EARLY DESIGN GUIDANCE OF THE EAST DESIGN REVIEW BOARD

Project Number: 3012300

Address: 505 11th Ave E

Date of Meeting: Wednesday, July 06, 2011

The fourth scheme (Option 4) was the preferred scheme and showed 24 units in three buildings.

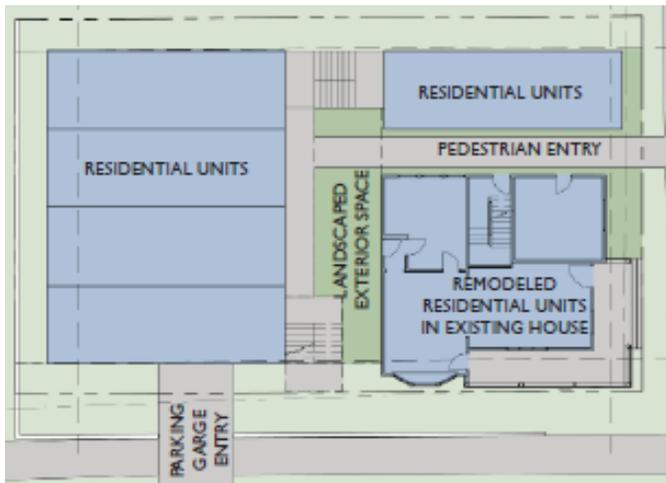
One of the buildings would be the existing structure, relocated to the southeast corner of the site and remodeled to include 4 apartments. A second building would include stacked flats facing the Park to the west. A third building would be stacked flats at the north property line, and connected to the second building via exterior stairs and walkways. 10 below grade parking spaces were shown with access from E. Republican St. This option would require departures to reduce the required setback at the west and east property lines, and a departure to allow more structure width and façade length at the north property line. Pros included saving the existing 1900 structure, the front porch of the structure would face the street corner, and units facing the park for “eyes on the street” and increased safety. Cons included the impacts related to placing a lot of building mass at the north property line

(shadows, bulk, scale impacts to the north).

- Opposed to the location of a four story building at the north property line, because of the rhythm of the buildings at 11th Ave E and the shadow/bulk impacts on the neighbor to the north

- The preferred design showing additions on two sides of the existing structure looks very cramped and out of character with nearby development.
- Support for considerate design to the Park, but the bigger need is considerate design on the sides facing the neighborhood.

The Board directed the applicant to consider removing the below grade parking, with the intent of reducing the appearance of height and bulk at the west edge and southwest corner.

The Board directed the applicant to modify the design to reflect this rhythm along 11th Ave E. A departure from the east property line setback might be justifiable, but the design should include large massing breaks at the north and south property lines. One way to achieve this is to place the existing structure at the east property line, but not add new structures to the north or south of it. It is also possible to achieve this by demolishing the existing structures and building new structures to respond to this street pattern.

At the Early Design Guidance Meeting, the Board expressed concern with the departures proposed at the north and west property lines, and the building mass proposed at the north property line. The Board stated that the proposal should be modified to meet Land Use Code requirements at the west and north property lines. Departures from the internal setbacks between buildings, the east property line setback, and the south property line setback could be considered.

The applicant should modify the proposed design to meet this guidance, and provide shadow studies of the proposed massing shadows on the Park and the property to the north.

At the Early Design Guidance Meeting, the Board noted the concerns listed in response to Guidelines A-1, A-2, and A-5. The applicant should consider dropping the building one story, possibly by removing below grade parking. The design of the building at the west property line should also include upper story setbacks to maximize light and air to the Park. The proposed height, bulk, and scale should respond to the context of the Park, the 11th Ave E. streetscape, and the grade changes on site.

The Board expressed concern with this proposed departure, given the pattern of massing on 11th Ave and the potential shadow and privacy impacts for the property to the north. The Board indicated they would be unlikely to consider this departure as proposed, due to the scale of the building at the north property line and how the proposed design disrupts the contextual pattern at 11th Ave E. (See response to guidelines A-2, A-5, B-1, and C-1 for more detail)
